# UNITED STATES PATENT AND TRADEMARK OFFICE

10/576,421

<b>Office Action Summary</b>	<b>Application No.</b> 10/576,421	<b>Applicant(s)</b> HAYASHI ET AL.	
	<b>Examiner</b> CLAIRE L. RADEMAKER	<b>Art Unit</b> 1795

## **DETAILED ACTION**

The following illustration (modification of Mizutani Figure 1) is provided for clarification:

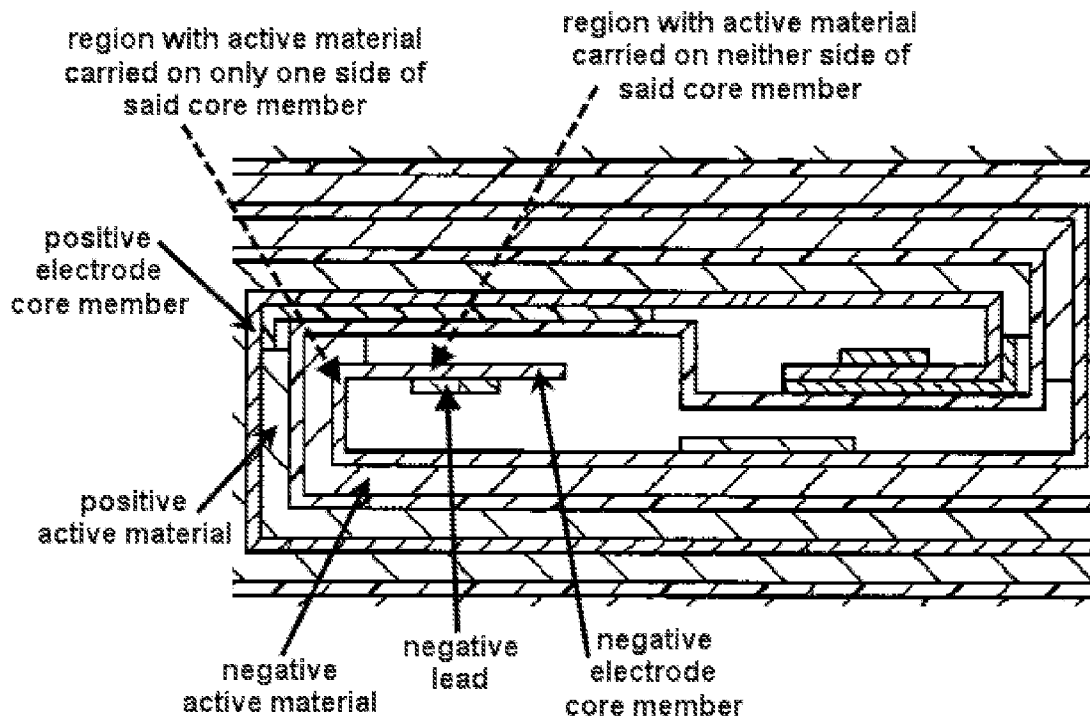
With regard to claims 1 and 3-4, Mizutani et al. teaches a lithium ion secondary battery (paragraphs [0037]-[0038]; Figure 1) including an electrode group that comprises:

a positive electrode comprising a positive electrode core member (15, paragraph [0044]; Figure 1) and a positive electrode active material layer (2, paragraphs [0038] & [0044]; Figure 1) carried on said positive electrode core member (paragraph [0044]; Figure 1),

a negative electrode comprising a negative electrode core member (16, paragraph [0047]; Figure 1) and a negative electrode active material layer (3, paragraph [0038]; Figure 1) carried on said negative electrode core member (paragraphs [0038] & [0047]; Figure 1),

a porous film (1, paragraphs [0038] & [0050]; Figure 1) disposed between said positive electrode and said negative electrode (paragraph [0038]; Figure 1), wherein said positive electrode and said negative electrode are wound (paragraph [0038]; Figure 1), and wherein said negative electrode has, on the initial winding side, a region where said negative electrode active material layer is carried on neither side of said core member (paragraph [0056]; Figure 1) and an adjoining region where said active material layer is carried on only one side of said core member (paragraph [0038]; Figure 1), and

a lead (9, paragraphs [0038] & [0056]; Figure 1) provided in the region of negative electrode where the active material layer is carried on neither side of said core member (9, paragraphs [0038] & [0056]; Figure 1).
